**Technical Service Bulletin (TSB)**  
**Digital Rear View Mirror (DRVM) Camera Washer Nozzle Not  
Cleaning Rear View Camera**

<b>REFERENCE:</b>	<b>TSB:</b> 23-049-22 REV. A <b>GROUP</b> 23 - Body	<b>Date:</b>	November 30, 2022	<b>REVISION:</b>	<b>23-049-22</b>
<b>VEHICLES AFFECTED:</b>	<b>**2022** - 2023 (WL) Jeep Grand Cherokee</b> This bulletin applies to vehicles built on or after <b>**April 13, 2022 (MDH 0413XX)</b> and built on or before <b>September 15, 2022 (MDH 0915XX)**</b> .			<b>MARKET APPLICABILITY:</b>	
				<input checked="" type="checkbox"/> NA	<input type="checkbox"/> IAP
				<input type="checkbox"/> EE	<input type="checkbox"/> MEA
				<input type="checkbox"/> SA	<input type="checkbox"/> CH
<b>CUSTOMER SYMPTOM:</b>	The liftgate DRVM camera washer nozzle is not cleaning the rear view camera.				
<b>CAUSE:</b>	Camera washing nozzle needs to be adjusted.

Fig. 1

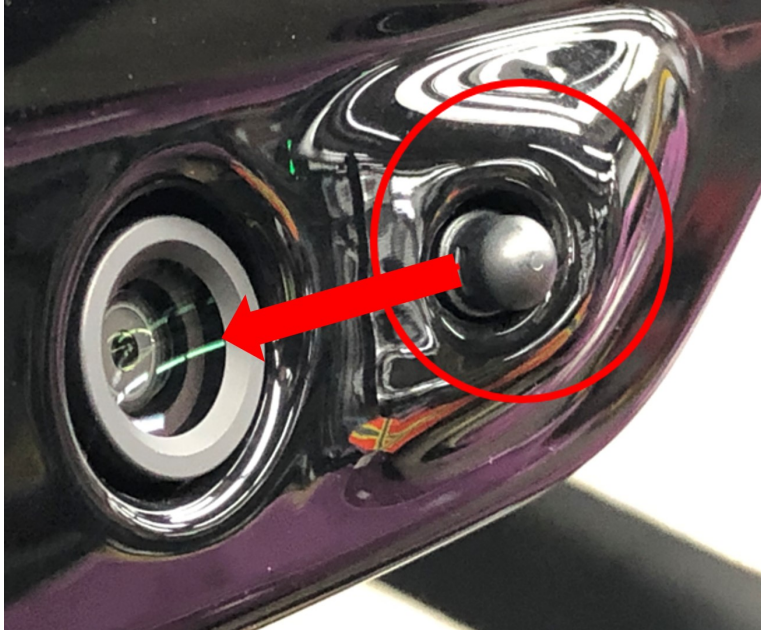
1. Operate the liftgate DRVM camera washer.
2. Inspect the liftgate DRVM camera washer nozzle to verify the nozzle opening is pointed and spraying in the direction towards the DRVM camera, or driver side of the vehicle (Fig. 1) .

3. Is the liftgate DRVM camera washer nozzle pointed and spraying in the direction towards the DRVM camera, or driver side of the vehicle (Fig. 1) ?
  - YES>>> This bulletin has been completed, use inspect LOP (23-43-20-9A) to close the active RSU.
  - NO>>> The liftgate DRVM camera washer nozzle is not pointed in the direction towards the camera. Proceed to [Step 1](#) of the Repair Procedure.

5. Operate the liftgate DRVM camera washer to verify the nozzle is spraying in the direction towards the DRVM camera (Fig. 1) .
